FINAL DRAINAGE REPORT

for
HAVEN VALLEY

El Paso County, Colorado

EL PASO COUNTY PCD FILE NO. ~~PUDSP-21-007~~ SF2323

DETENTION BASIN OUTLET STRUCTURE DESIGN

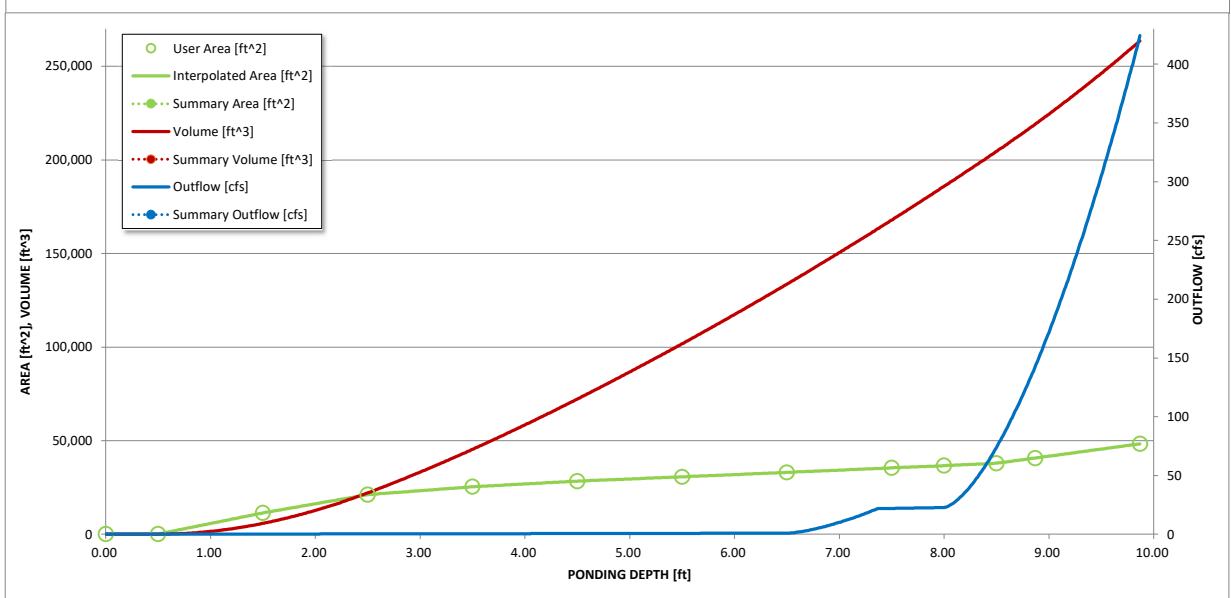
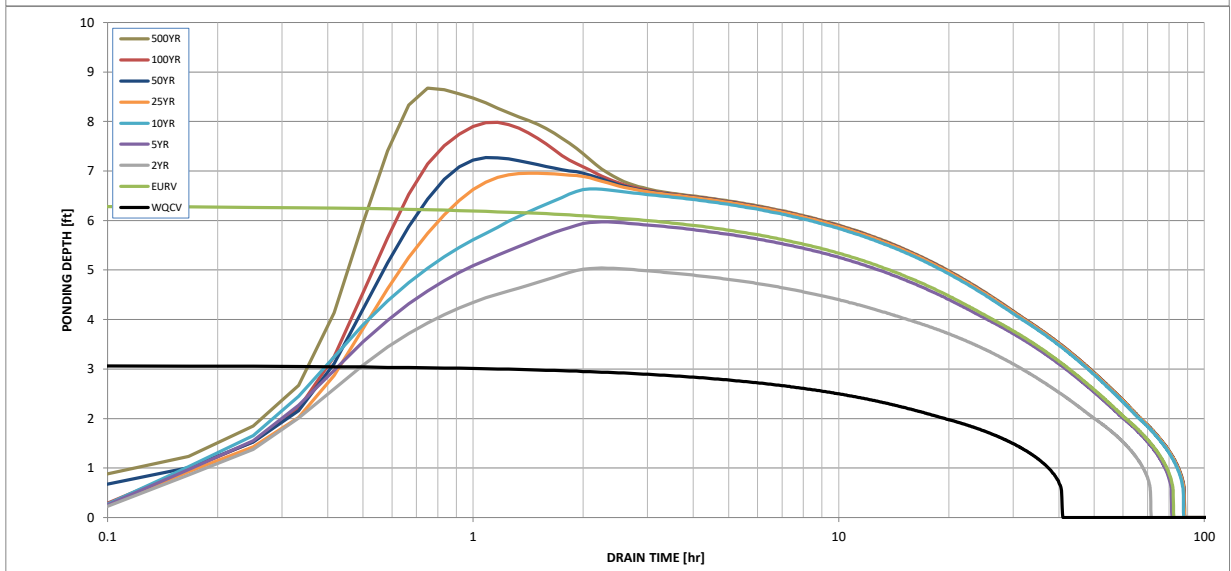
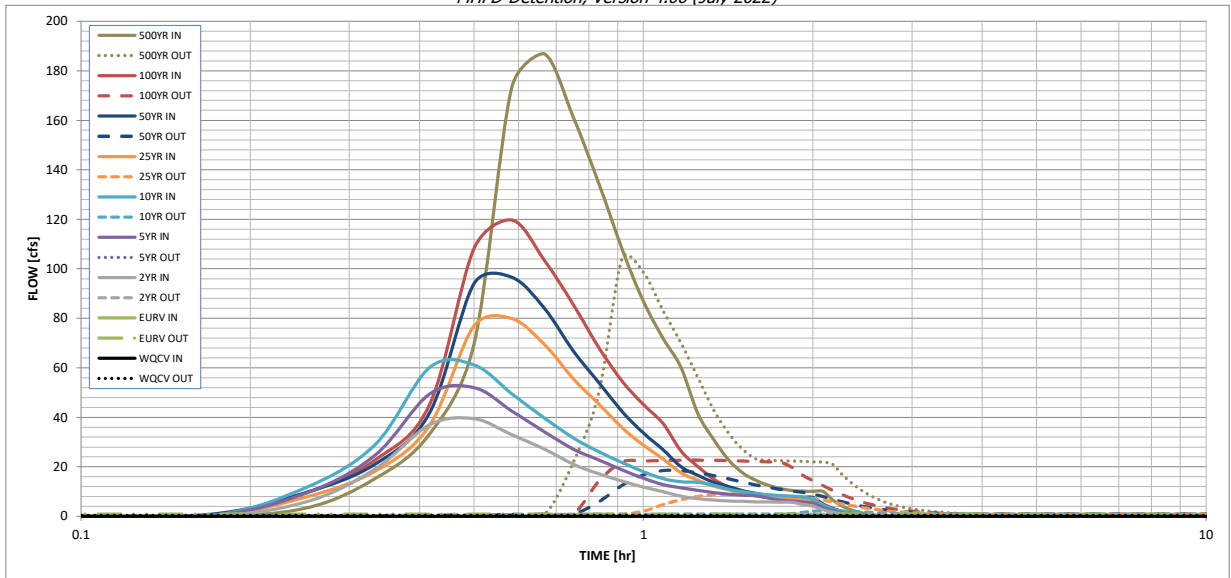
Does not match what is shown on plan details.

Per senate bill and ECM 3.2.5.F, 97% of 5 yr storm event shall drain within 72 hrs. Revise accordingly.

PROPOSED CONDITIONS DRAINAGE PLAN

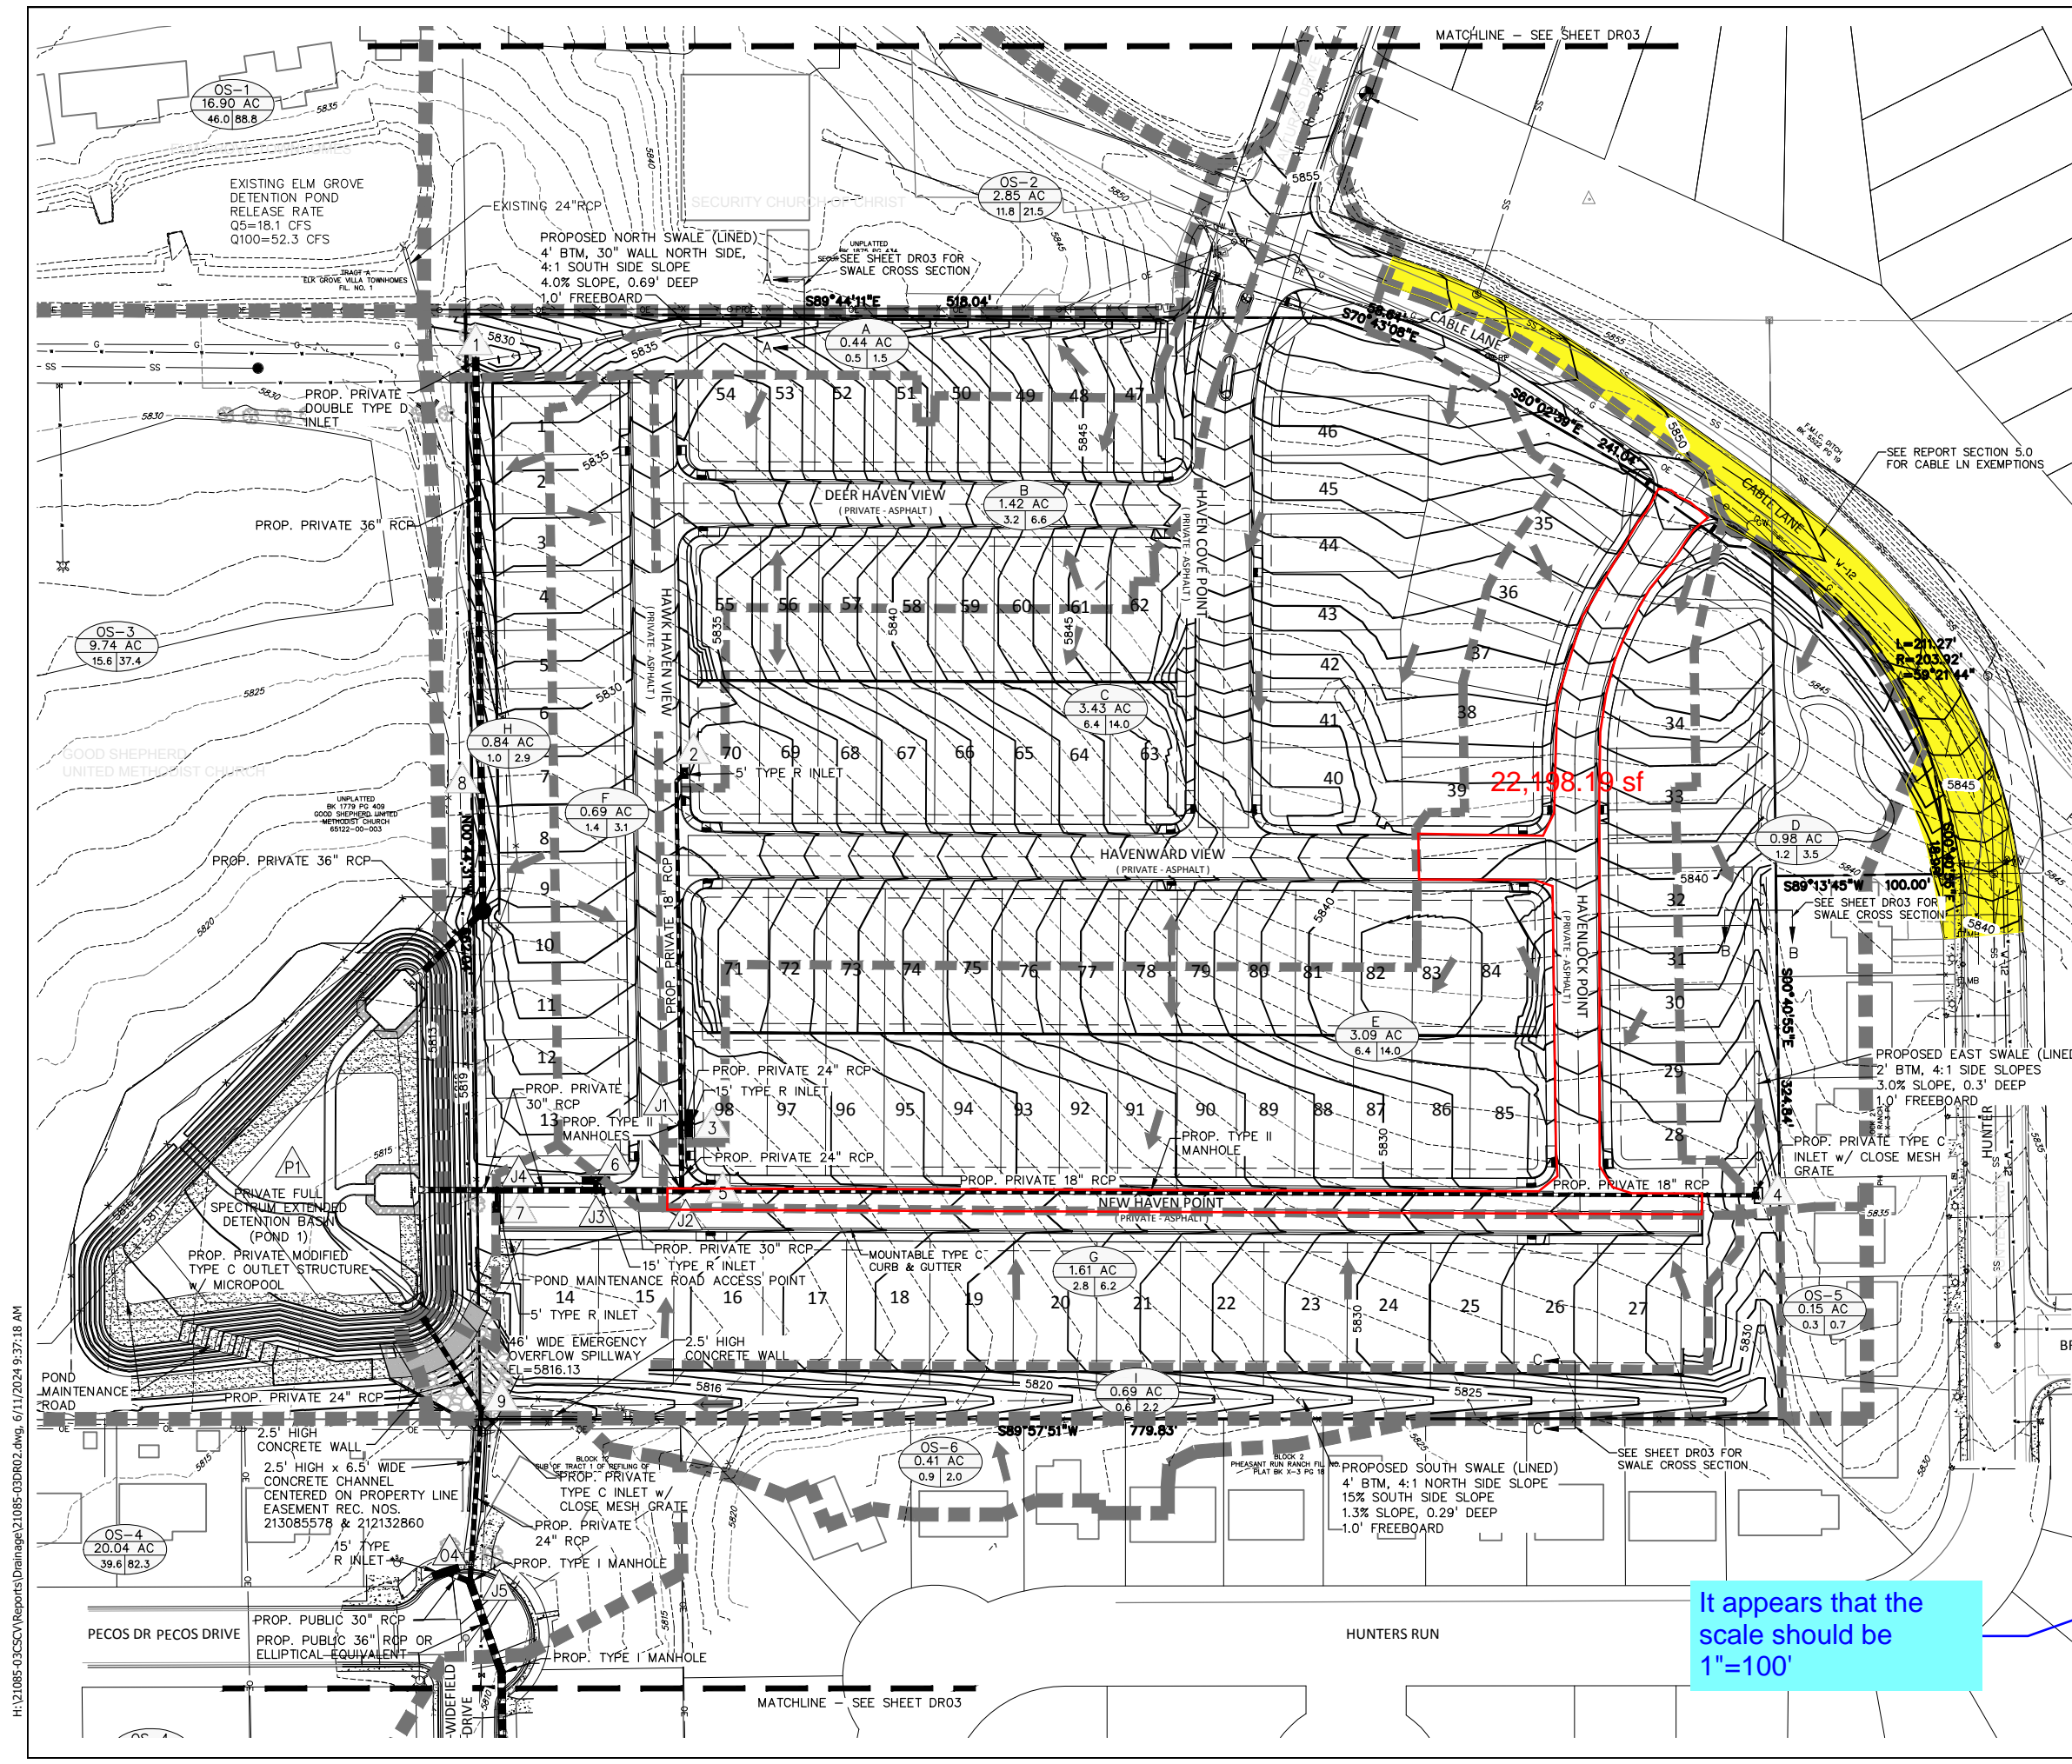
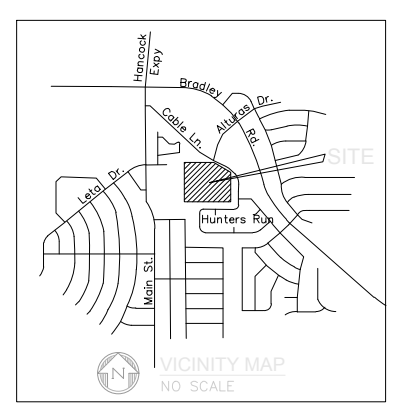
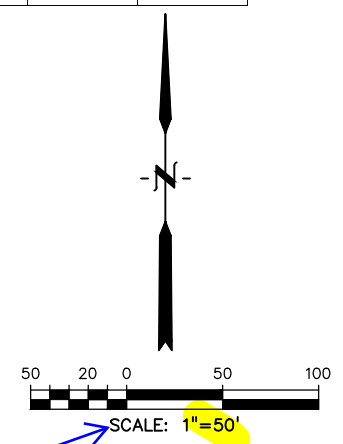
It appears that the scale should be 1"=100'

PROPOSED CONDITIONS
 DRAINAGE PLAN

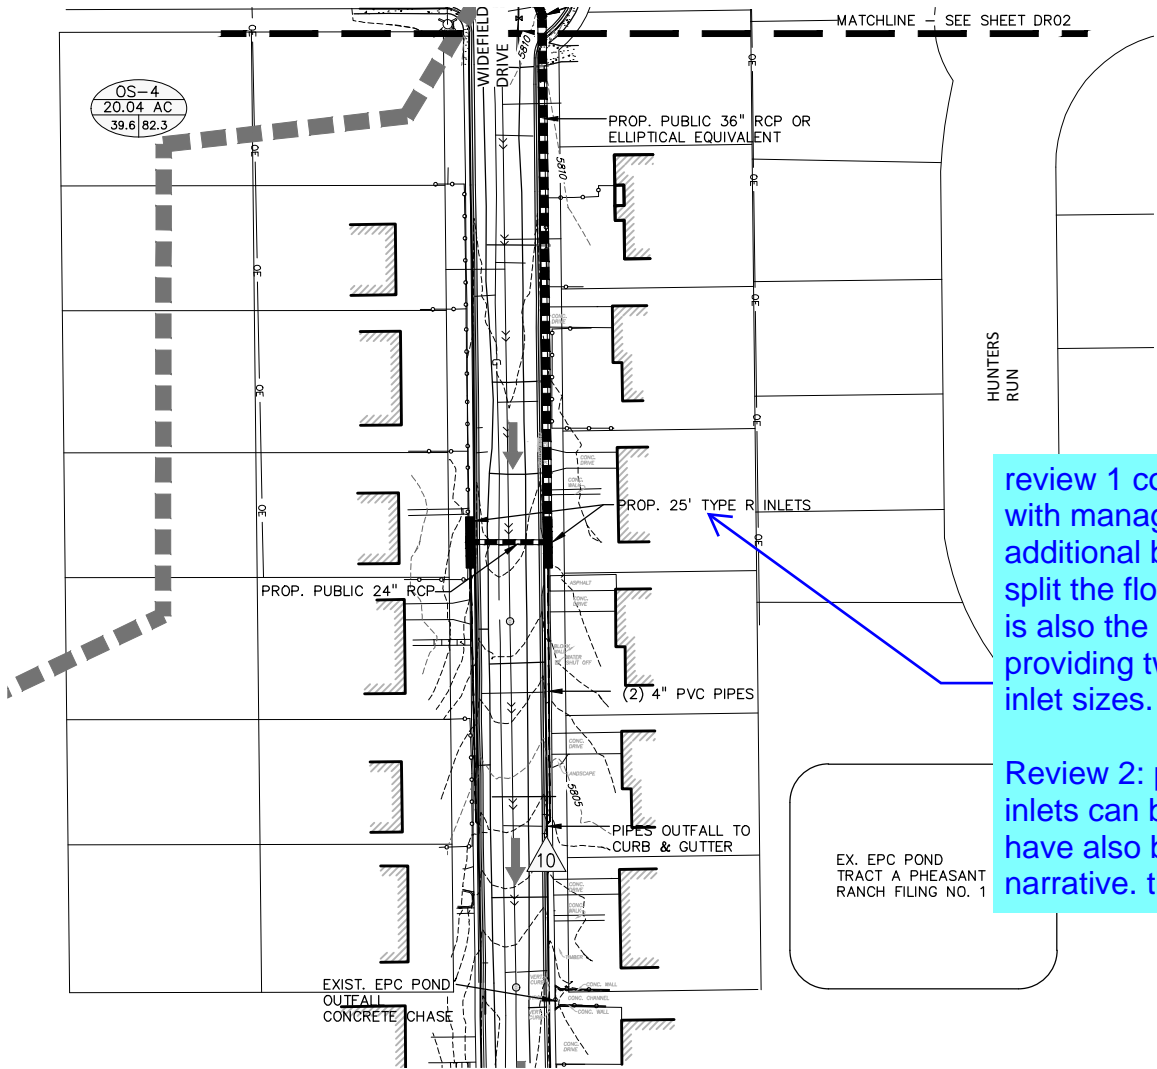
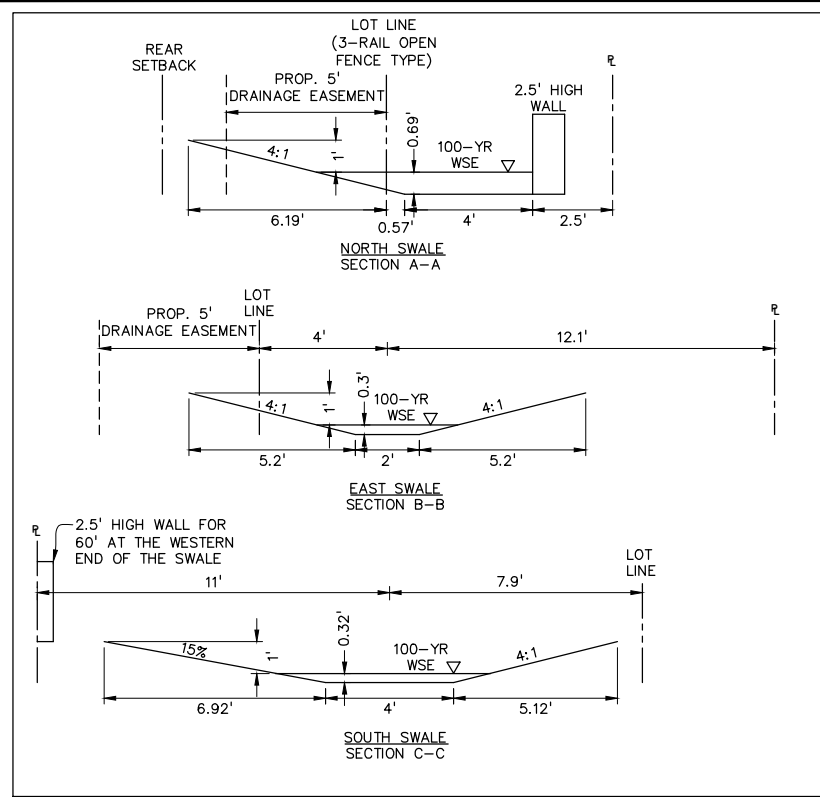
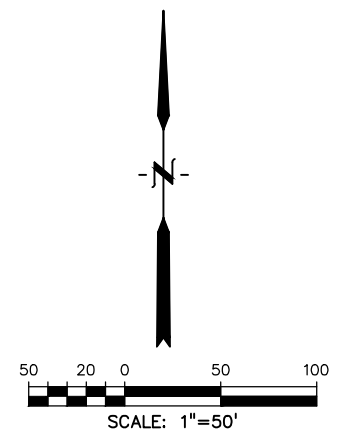
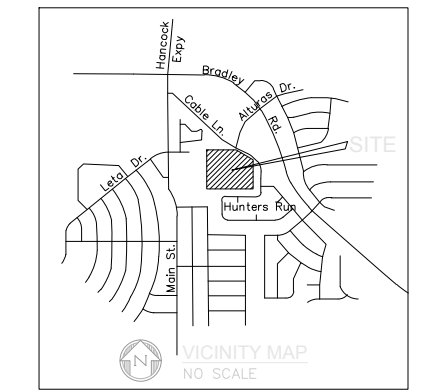
review 1 comment: After discussion with management, please provide an additional bubbler on the west side to split the flows being released. Concern is also the size of the 25' inlet and providing two would enable smaller inlet sizes.

Review 2: please verify whether these inlets can be reduced. Comments have also been provided in the narrative. the CD's indicate 15' inlets
